BREAK ROOM CABINETRY	CSKA 4
WESTFORD TOWN HALL ADDITION & RENOVATIONS 55 MAIN STREET, WESTFORD, MA	
KANG ASSOCIATES, INC.	12/15/09 (4) · 1/4" = 1'-0"

DRAWING TITLE: ELECTRICAL PARTIAL SITE PLAN REFERENCE DRAWING E5

NANGLE ENGINEERING INCORPORATED 32 Prince Street Danvers, MA 01923 Tel. (978) 777-7650 Fax (978) 777-7653	PROJECT: WESTFORD TOWN HALL ADDITION & RENOVATIONS	DATE: 12/15/09 SCALE: 1/8"=1'-0" DRAWN BY: CWN CHECKED BY: GPN
	DRAWING TITLE: ARCHIVE STORAGE AND BREAKROOM REFERENCE DRAWINGS E3 & E5	DRAWING NUMBER: SKE-8

NANGLE ENGINEERING INCORPORATED 32 Prince Street Danvers, MA 01923 Tel. (978) 777-7650 Fax (978) 777-7653	PROJECT: WESTFORD TOWN HALL ADDITION & RENOVATIONS	DATE: 6/18/10 SCALE: 1/8"=1'-0" DRAWN BY: CWN CHECKED BY: GPN
	DRAWING TITLE: MEETING ROOM REVISIONS REFERENCE DRAWINGS E3 & E5	DRAWING NUMBER: SKE-12 /REV 11

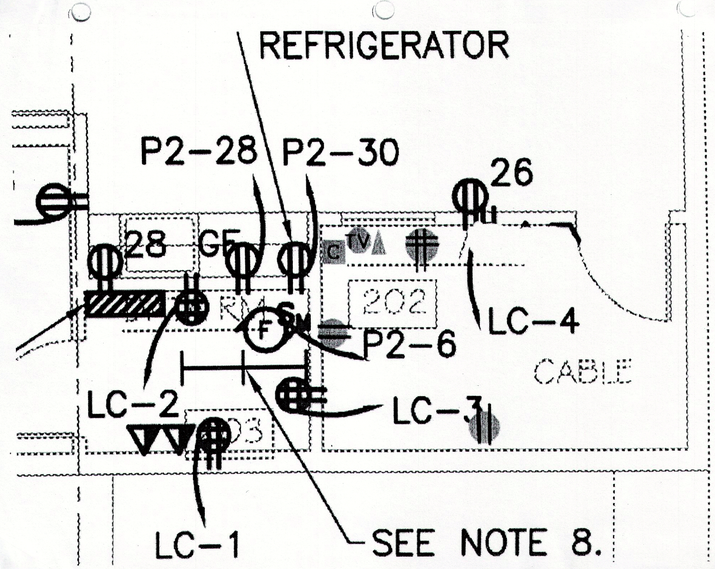
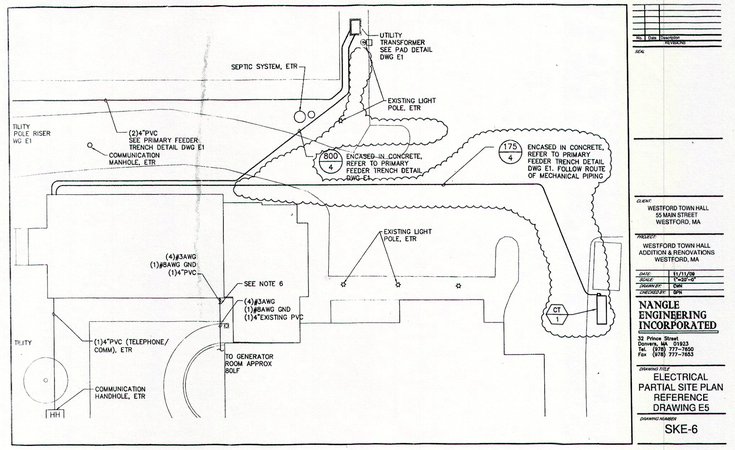
1 BREAK RM.
(14/A9 REVISED)

1 LIGHTING PLAN

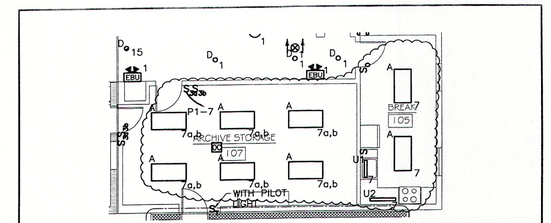
LIGHTING NOTE:
FIXTURE TYPE 'U1' SHALL BE COLUMBIA CAT NO UC24-117-EU
FIXTURE TYPE 'U2' SHALL BE COLUMBIA CAT. NO. UC36-125-EU
OR APPROVED EQUAL.

2 POWER PLAN

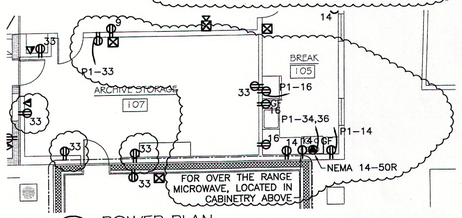
POWER NOTE:
REPLACE 20A/2P CIRCUIT BREAKER IN PANEL P1 WITH 50A/2P CIRCUIT BREAKER TO FEED NEW RANGE. PROVIDE NEW 50A FEEDER FROM RANGE RECEPTACLE TO PANEL P1.

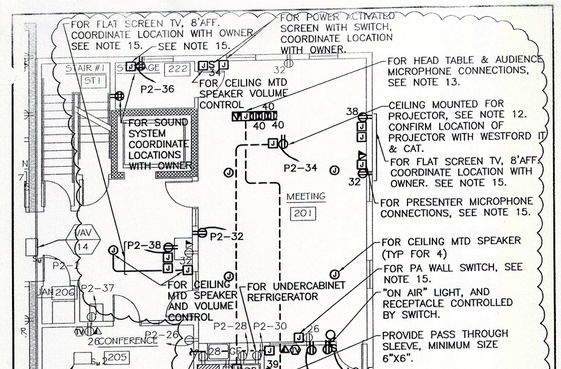
11. PROVIDE (1)2" EMT WITH PULLSTRING FROM COMMUNICATIONS UTILITY BUILDING SERVICE ENTRANCE TO 4"SQUARE JUNCTION BOX IN DATA ROOM.
12. PROVIDE JUNCTION BOX AT PROJECTOR LOCATION AND AT WALL WITH DE-15 CONNECTOR PLATE AT EACH JUNCTION BOX, AND VGA WIRING BETWEEN JUNCTION BOXES, COORDINATE EXACT LOCATION WITH OWNER.
13. COORDINATE FLOOR BOX LOCATIONS AND REQUIREMENTS WITH WESTFORD IT & CAT. PROVIDE 2" EMT WITH PULLSTRING FROM FLOOR BOX TO STUB UP IN BACK CORNER OF CABLE/AV ROOM.
14. PROVIDE (2)2" EMT WITH PULLSTRING FROM COMMUNICATIONS UTILITY BUILDING SERVICE ENTRANCE TO 4"SQUARE JUNCTION BOX IN CABLE/AV ROOM.
15. PROVIDE 2" EMT SLEEVE WITH PULLSTRING FROM WALLBOX TO STUB UP ABOVE CEILING. COORDINATE SIZE OF WALL BOX WITH WESTFORD IT & CAT.
